Planning Commission Staff Report

Project Type: Amended Architectural Elevations

Description: **Chesterfield Commons, Outlot 6 (Buffalo Wild Wings):** Amended Architectural Elevations, Architect’s Statement of Design and Light-Emitting Diode (LED) Band for a 1.747 acre lot of land zoned “C8” Planned Commercial District located on the south side of Chesterfield Airport Road, east of the intersection with Boones Crossing.

SPECIFICATIONS
ONE(1) ROW OF LEMON YELLOW
SLOAN BRAND LEDStripe
(YELLOW POLYCARBONATE LENS / WHITE LEDS)
PART # 701189A-LY

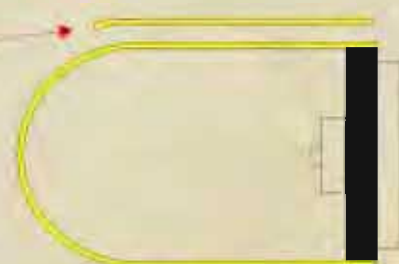
The building currently has two green neon light bands on all four façades of the building: one along the roofline and the second one approximately 5 feet below the roofline. These were approved in 2000 by the Architectural Review Board and Planning Commission. The proposal includes replacing both neon light bands along the roofline with a single “lemon” yellow LED strip with a top film. This lighting is intended to be accent lighting only and will not cause any light trespass. The Lighting Ordinance, adopted in 2005, prohibits the use of visible neon tubing for an architectural element but it does allow for LED technology to be used subject to the review and approval by the City of Chesterfield.

EXTERIOR ELEVATIONS

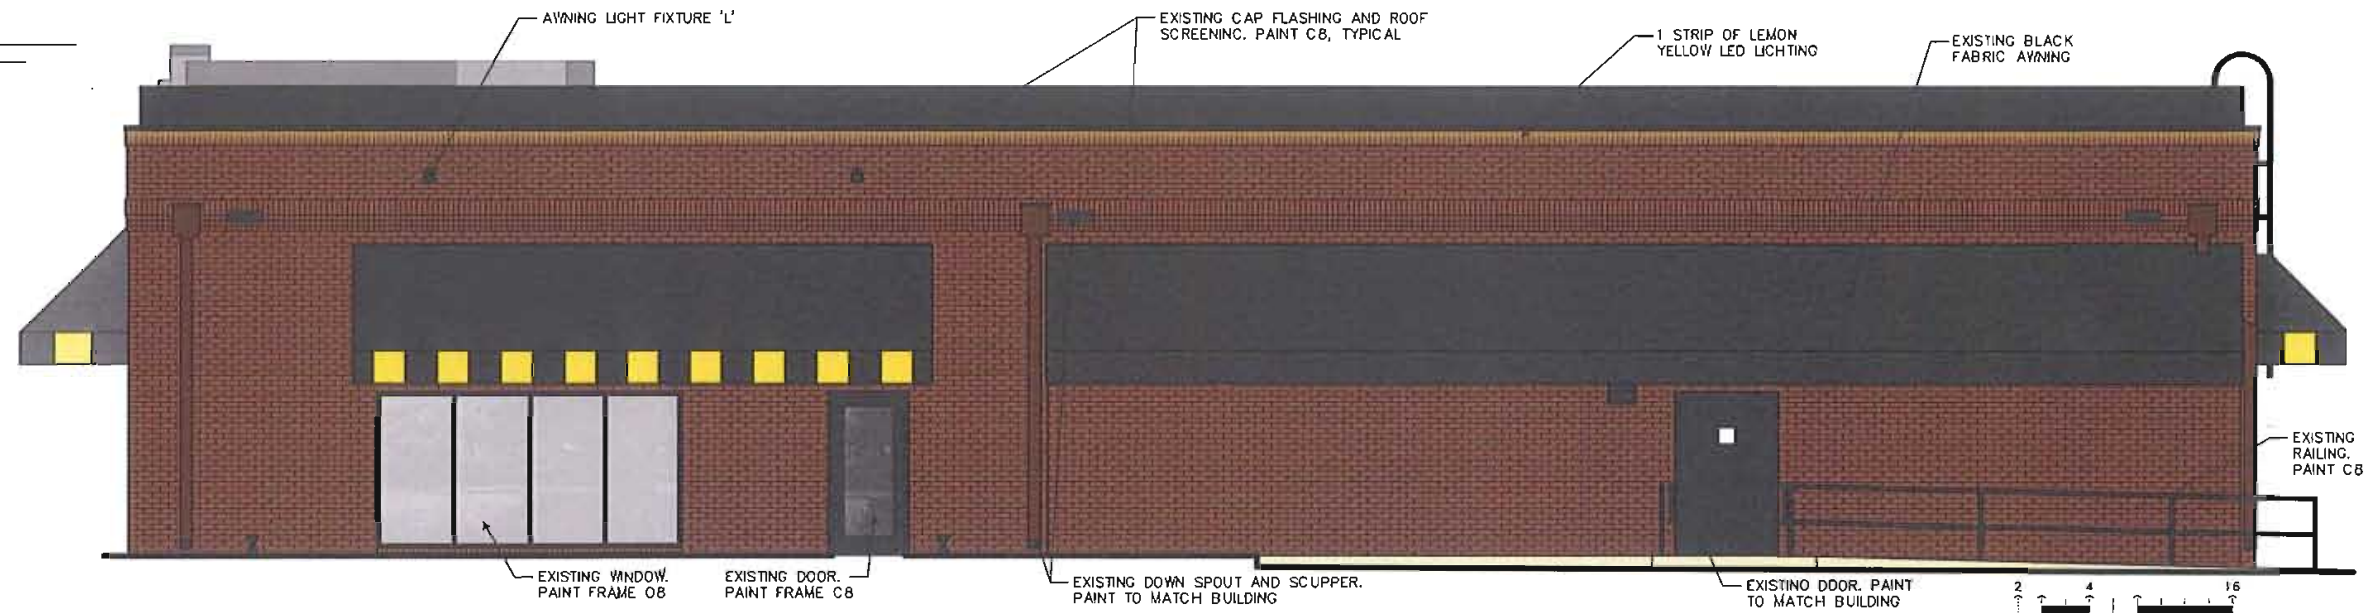
The proposed changes to the building include removing the wall with the sloped metal roof, on the west elevation, and adding a new patio with black railing and a “uniclad matte black” metal canopy. The new exterior wall along the patio will be comprised of EIFS to match the existing brick color on the building and the proposed roof, columns, and railing will be painted black. The face of the metal canopy roof will be painted in alternating colors of black and “honeycomb” yellow.

The front entry structure will remain the same, but the brick façade will be replaced with “social butterfly” yellow EIFS. The black EIFS panel on the top of the front entry is proposed to serve as a background for the wall sign. The existing awnings on the entry will be removed and replaced with “uniclad matte black” metal overhangs. The existing awning frames on other
